**EXETER, NEW HAMPSHIRE
WASTEWATER TREATMENT FACILITY
UPGRADE**

**30% DESIGN
VALUE ENGINEERING
WORKSHOP
DECEMBER 7-11, 2015**

**FINAL REPORT
January 13, 2016**

ELEMENT: BNR Tank Sizing

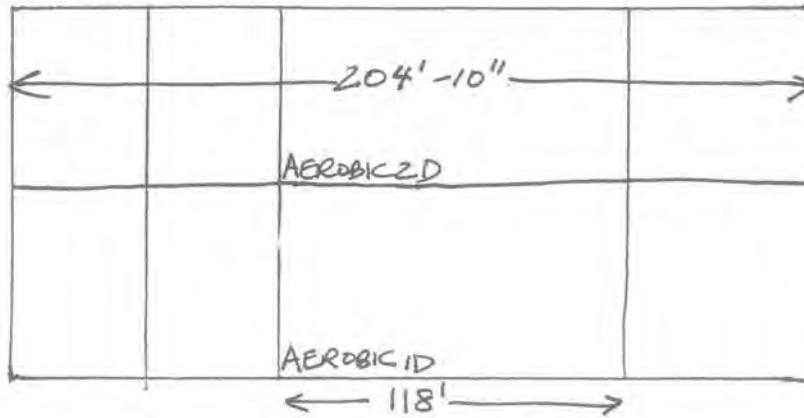
AEROBIC "D" LENGTHS TO BE REDUCED BY 30%

W-P DRAWINGS PR-29,30 #31

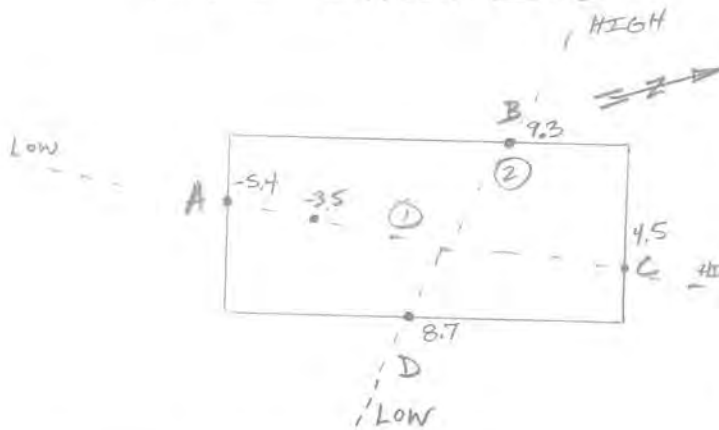
CONFIRMED PER
 EEI DRAWING SP-18
 FROM PDR

EXISTING GRADE @ ±13.0 UNDER PROPOSED SHB FOOTPRINT

IMPACT OF LOCATION ALT. B FOR SHB

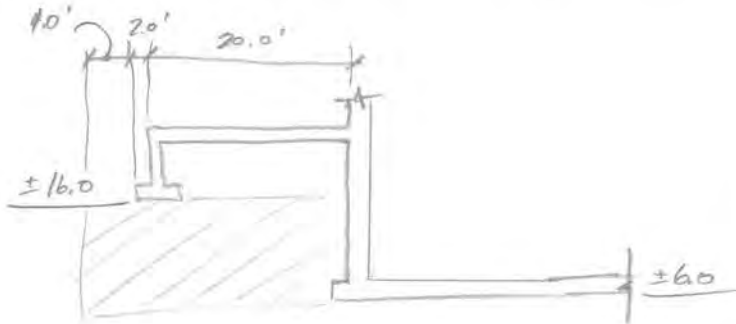
MUCH LESS THAN W/P QNTY OF 2,340 CY

$$\text{VOLUME} = (5.5')(94')(58') / 27 + [2(94) + 2(58)] 15.1 / 27 = \underline{\underline{1,280 \text{ CY}}}$$

CALCULATION SHEET
ELEMENT: AT1#2

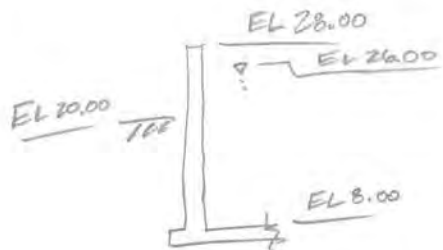
RESIZE AT1#2 BASED ON THE ADDITION OF PRIMARY TREATMENT
